ADDENDUM NO. 03
 PROJECT NO. 16-064

Reference Bid Documents issued for IFB 17-004

HVAC Replacement project
 Jordan Park Apartments
 St. Petersburg, Florida 33703

Date: March 21, 2017

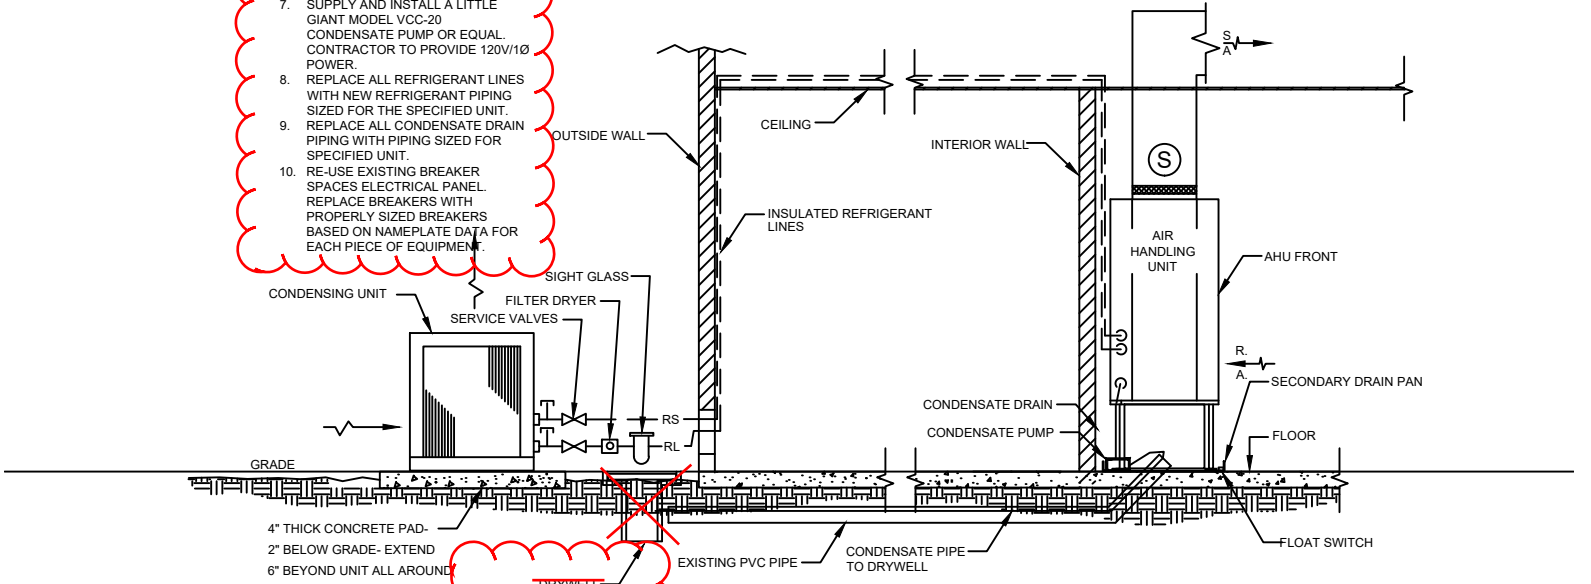
1. Delete Drywells shown on diagrams from scope of work.
 Drywells NOT required for either individual apartments OR for the community center HVAC installation. Condensate to drain onto grade/grass typical throughout development.
2. Scope of work does NOT include trenching & replacing slabs for new condensate lines to be installed below grade. A condensate pump is req'd for each apartment.
3. Per SPHA (Owner) – shark bites are NOT acceptable. Replace hydronic feed connection to existing heat pump units between ball valves w/standard welded new piping.
4. In some locations the refrigerant sleeve is installed directly below existing AHU in center of closet, which would prevent placing the overflow pan on floor below unit. In these instances contractor to provide simple framed platform for overflow pan so that sleeve may be re-used.

A/C SYSTEM DETAIL WITH VERTICAL AIR HANDLING UNIT & CONDENSING UNIT MOUNTED AT GRADE
NOT TO SCALE

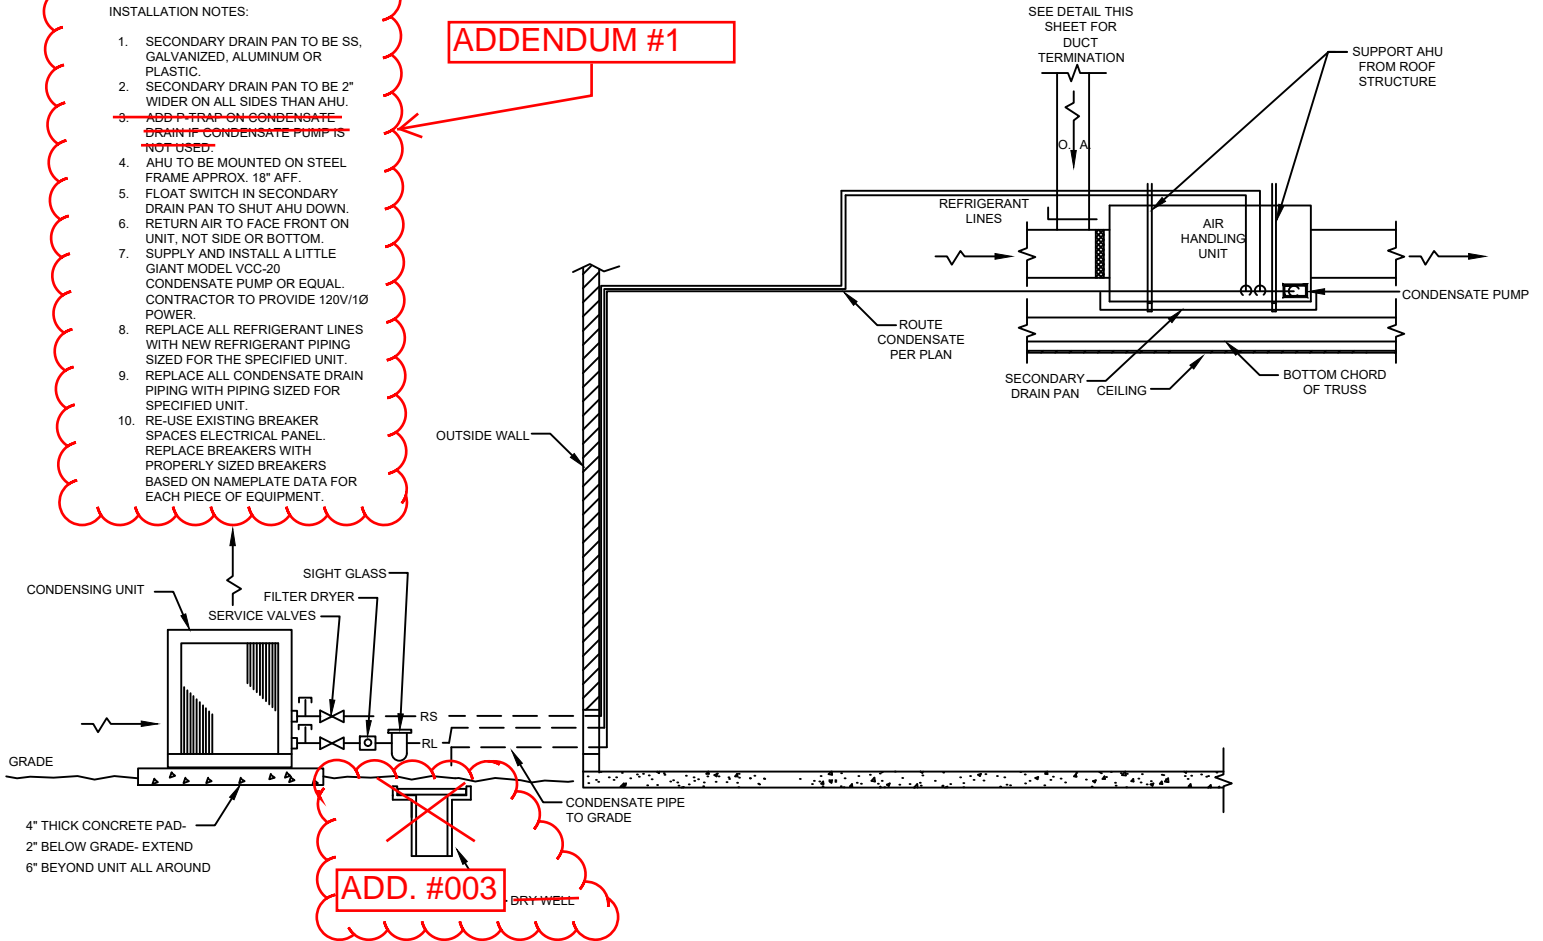
1. SECONDARY DRAIN PAN TO BE SS, GALVANIZED, ALUMINUM OR PLASTIC.
2. SECONDARY DRAIN PAN TO BE 2" WIDER ON ALL SIDES THAN AHU.
3. ~~ADD TRAP ON CONDENSATE DRAIN IF CONDENSATE PUMP IS NOT USED.~~
4. AHU TO BE MOUNTED ON STEEL FRAME APPROX. 18" AFF.
5. FLOAT SWITCH IN SECONDARY DRAIN PAN TO SHUT AHU DOWN.
6. RETURN AIR TO FACE FRONT ON UNIT, NOT SIDE OR BOTTOM.
7. SUPPLY AND INSTALL A LITTLE GIANT MODEL VCC-20 CONDENSATE PUMP OR EQUAL. CONTRACTOR TO PROVIDE 120V/10 AMPERES.
8. REPLACE ALL REFRIGERANT LINES WITH NEW REFRIGERANT PIPING SIZED FOR THE SPECIFIED UNIT.
9. REPLACE ALL CONDENSATE DRAIN PIPING WITH PIPING SIZED FOR SPECIFIED UNIT.
10. RE-USE EXISTING BREAKER SPACES ELECTRICAL PANEL. REPLACE BREAKERS WITH PROPERLY SIZED BREAKERS BASED ON NAMEPLATE DATA FOR EACH PIECE OF EQUIPMENT.

ADD. #003

A/C SYSTEM DETAIL WITH HORIZONTAL AIR HANDLING UNIT & CONDENSING UNIT MOUNTED AT GRADE
 NOT TO SCALE

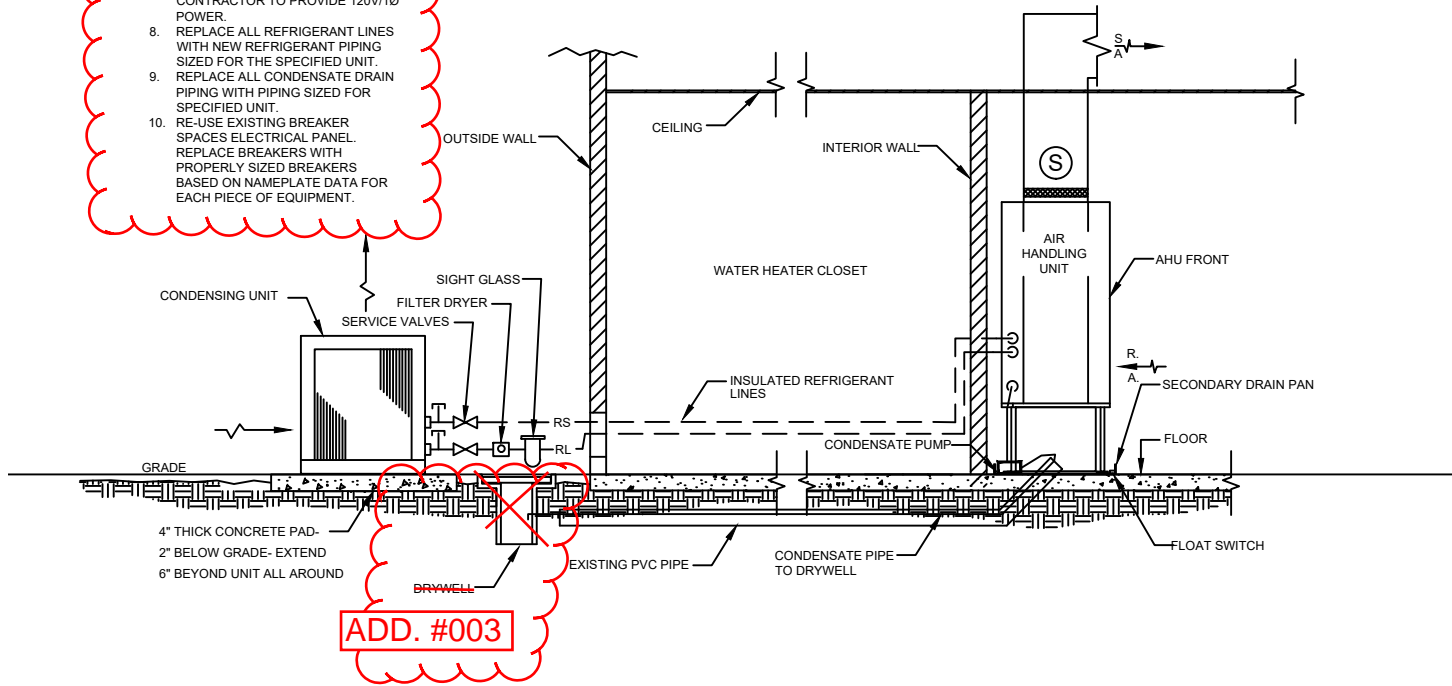
1. SECONDARY DRAIN PAN TO BE SS, GALVANIZED, ALUMINUM OR PLASTIC
2. SECONDARY DRAIN PAN TO BE 2" WIDER ON ALL SIDES THAN AHU.
3. ~~ADD P-TRAP ON CONDENSATE DRAIN IF CONDENSATE PUMP IS NOT USED.~~
4. AHU TO BE MOUNTED ON STEEL FRAME APPROX. 18" AFF.
5. FLOAT SWITCH IN SECONDARY DRAIN PAN TO SHUT AHU DOWN.
6. RETURN AIR TO FACE FRONT ON UNIT, NOT SIDE OR BOTTOM.
7. SUPPLY AND INSTALL A LITTLE GIANT MODEL VCC-20 CONDENSATE PUMP OR EQUAL. CONTRACTOR TO PROVIDE 120V/1Ø POWER.
8. REPLACE ALL REFRIGERANT LINES WITH NEW REFRIGERANT PIPING SIZED FOR THE SPECIFIED UNIT.
9. REPLACE ALL CONDENSATE DRAIN PIPING WITH PIPING SIZED FOR SPECIFIED UNIT.
10. RE-USE EXISTING BREAKER SPACES ELECTRICAL PANEL. REPLACE BREAKERS WITH PROPERLY SIZED BREAKERS BASED ON NAMEPLATE DATA FOR EACH PIECE OF EQUIPMENT.
